QUALITY ASSURANCE PROGRAM
MANAGEMENT CORRECTIVE ACTION REPORT
MCAR-1

REPORT NO.: 47

SUBJECT: MCAR 47 (Issued 1/29/81)
Auxiliary Building Seismic Analysis

PROJECT: Consumers Power Company
Midland Plant Units 1 and 2
Bechtel Job 7220

FIGURE 47-1
 REVISED LUMPED MASS MODEL OF
 THE AUXILIARY BUILDING FOR THE
 NORTH-SOUTH EARTHQUAKE
 MIDLAND PLANT UNITS 1&2
 CONSUMERS POWER COMPANY

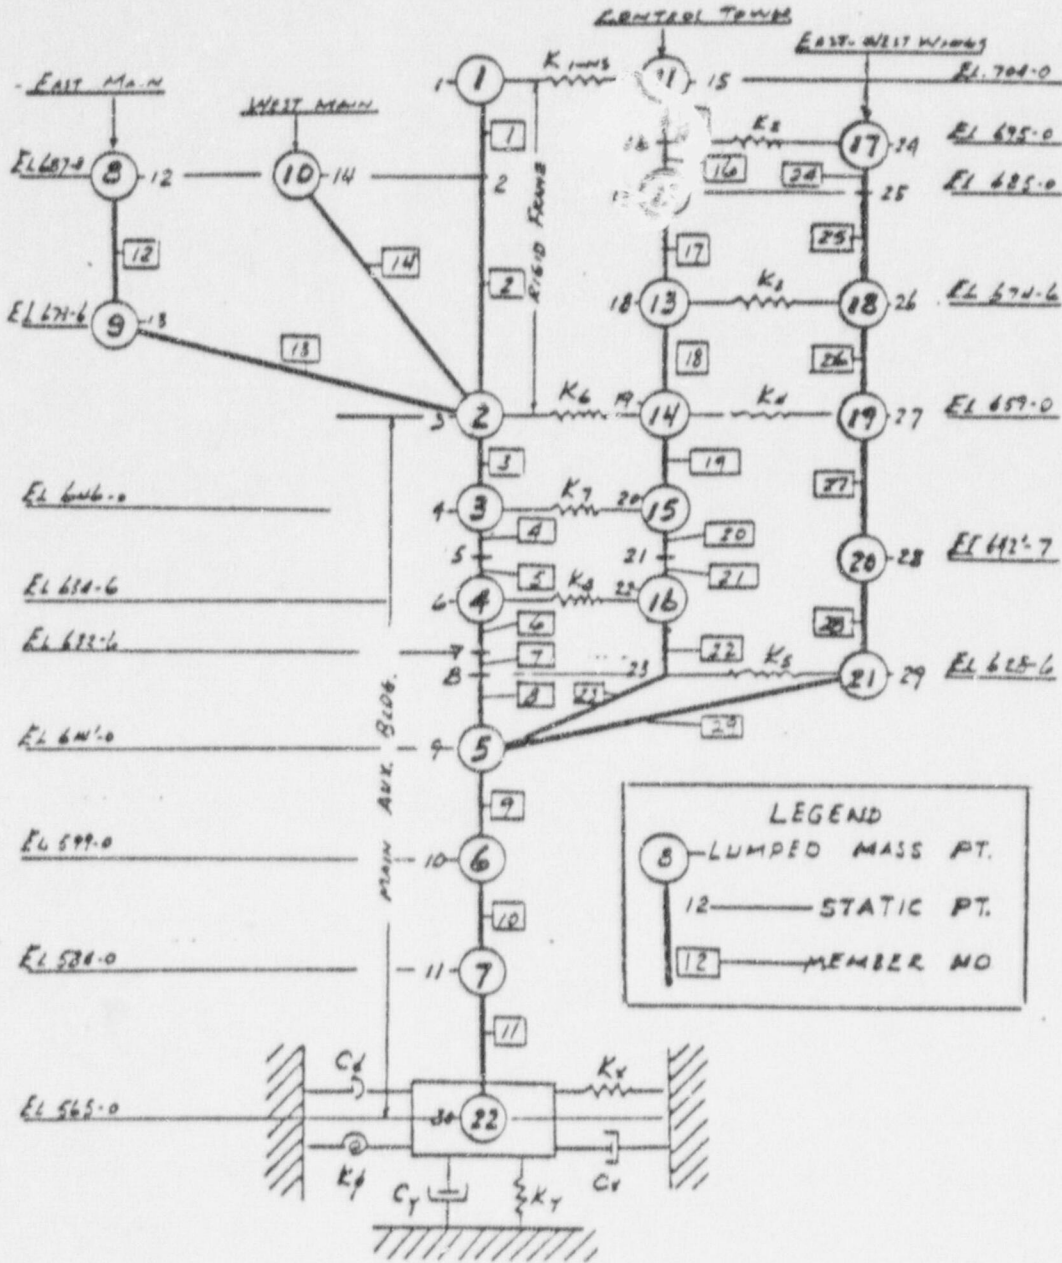
An investigation into the north-south 1977 seismic model (FSAR Figure 3.7-10) has been initiated to determine the possible changes in the building forces and the floor response spectra curves due to modeling the structural connections between the control tower and the main auxiliary building (el 614' to 659') and separating the structural properties for each portion (Figure 47-1). The east-west and vertical dynamic models are not affected.

The investigation with this model as shown in Figure 47-1 considers:

- 1) Complete the actions described in Investigation, above.
- 2) Establish whether this is "reportable" based on the results of the investigation described above.
- 3) During the week ending January 23, 1981, the assumption that the control tower and the main portion of the auxiliary building is a nonintegral unit between el 614' and 659' was incorporated into a modified model of the auxiliary building. Accordingly, this action is complete.

FIGURE 47-2

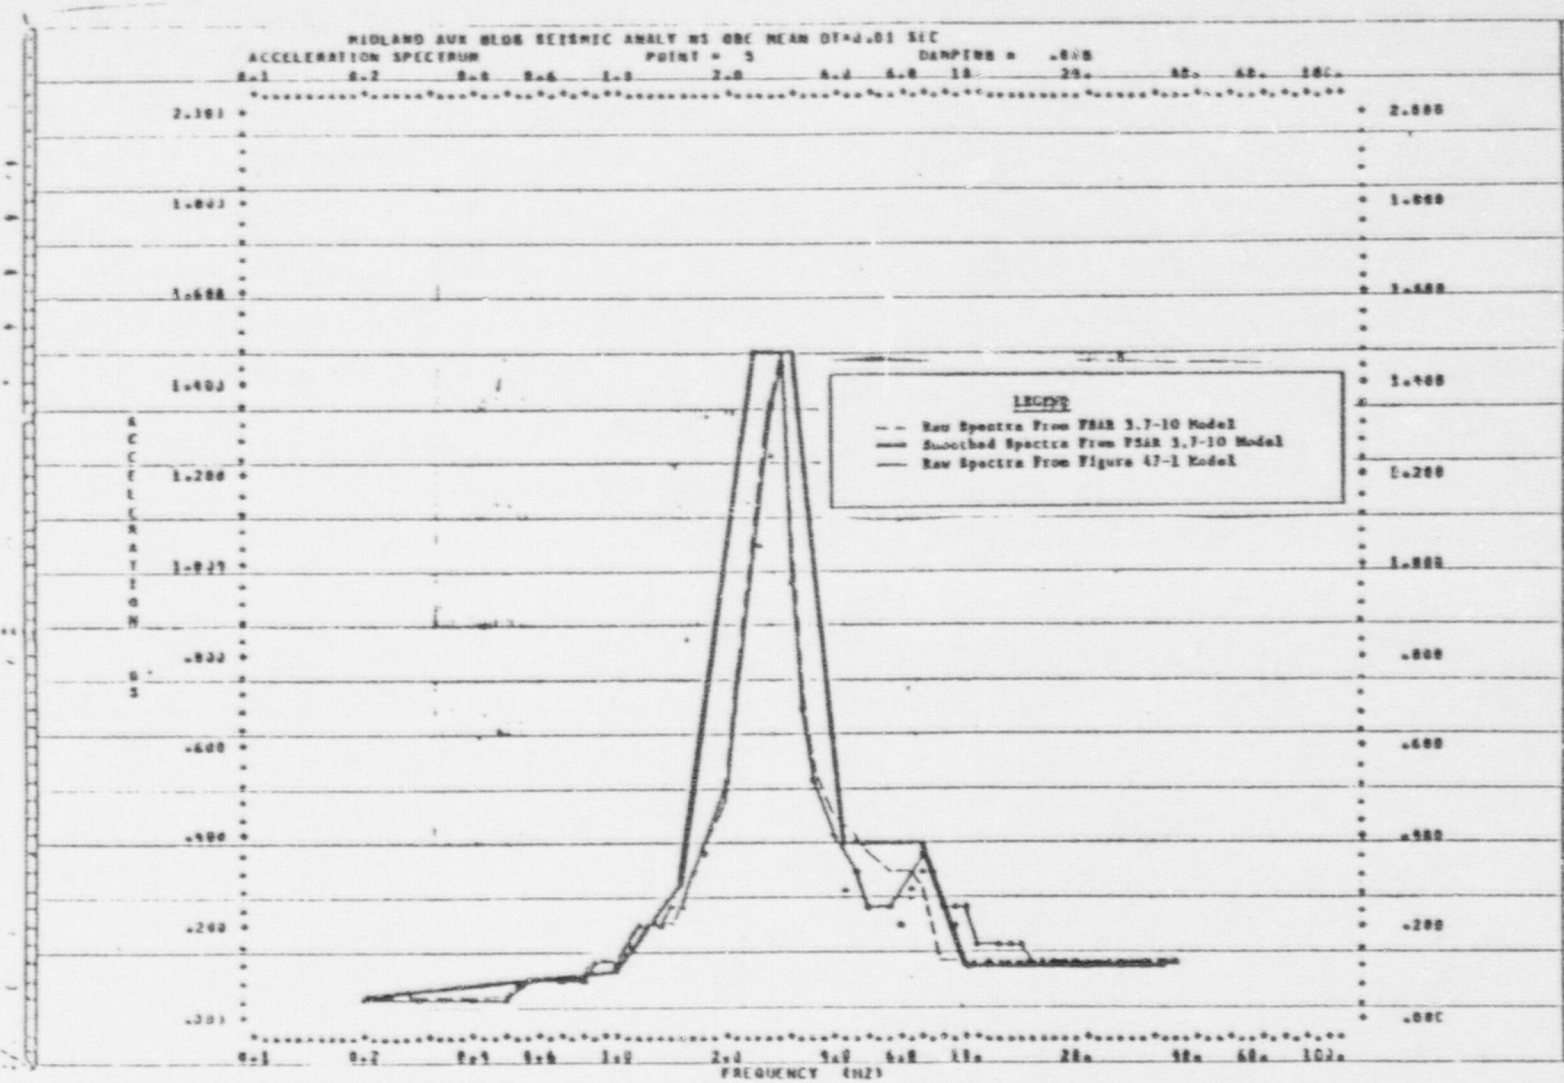
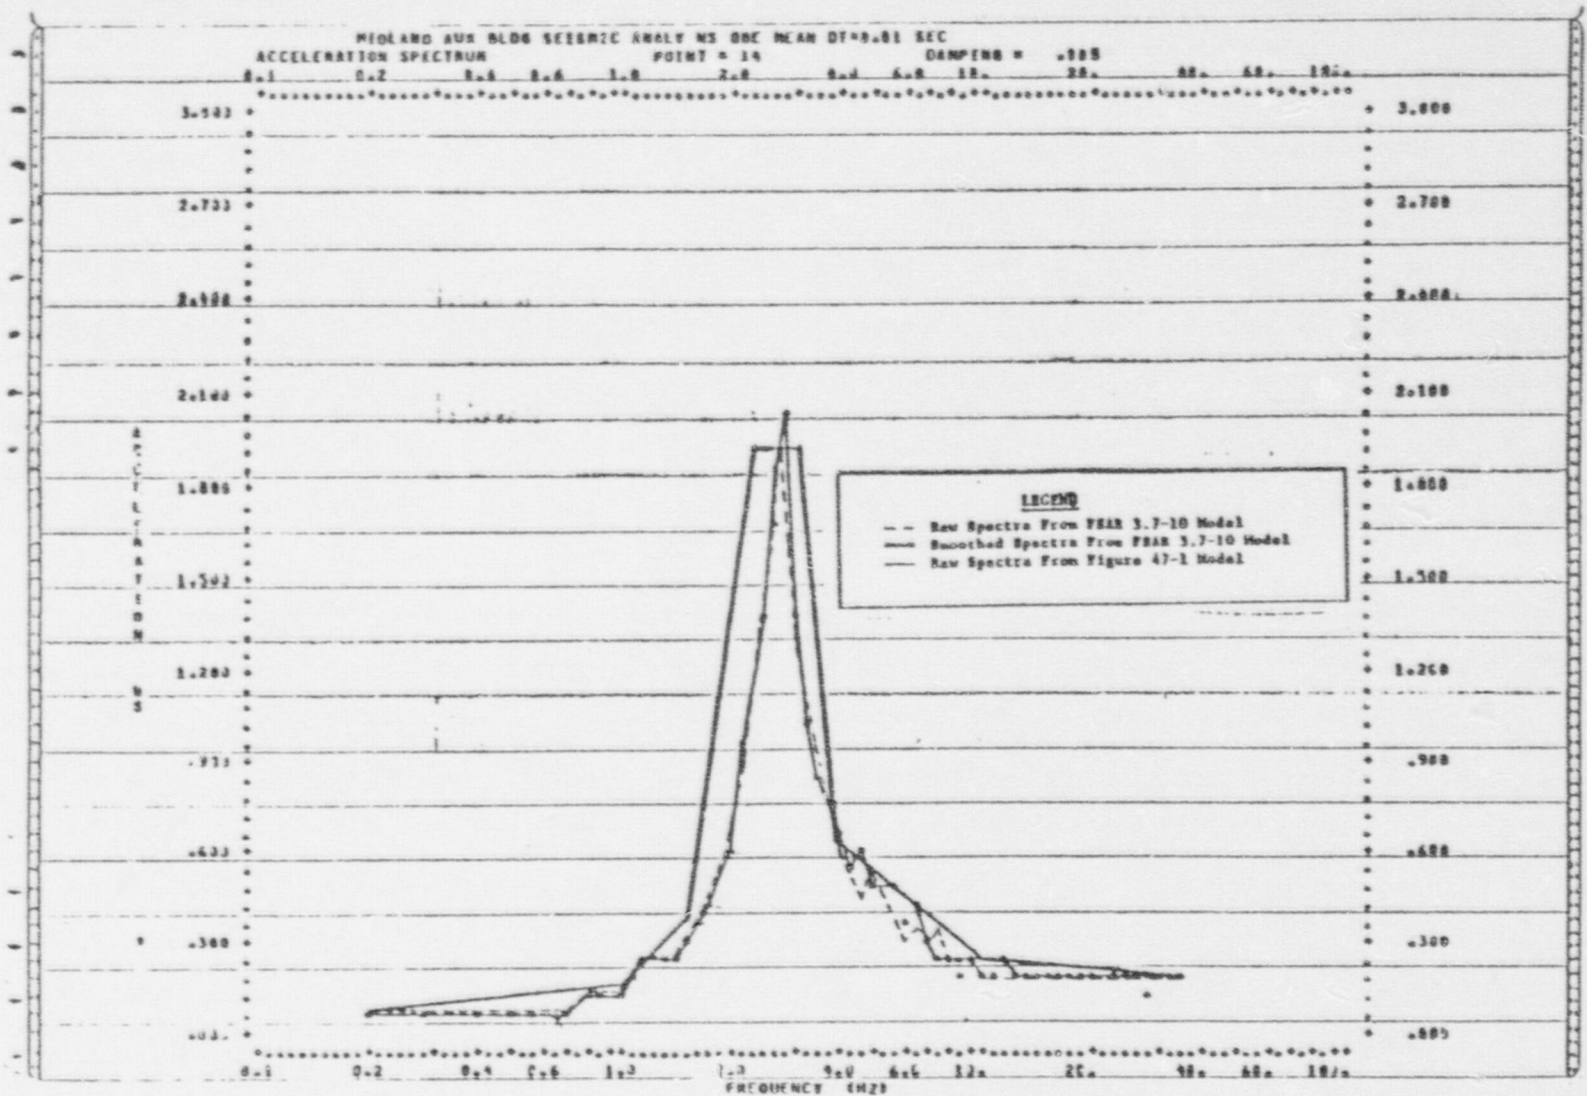
- 4) A comparison of the in-structure response spectra curves has been made and indicates that the majority of the floor spectra curves have little or no change as shown by Figures 47-2 and 47-3. The greatest changes were confined to the structural steel superstructure, control tower, and electrical penetration areas above el 659' as shown by Figures 47-4, 47-5, and 47-6. The potential safety impact of these changes is being evaluated for selected piping systems and equipment located in these areas. These piping systems and equipment were selected based upon the potential for greatest change.
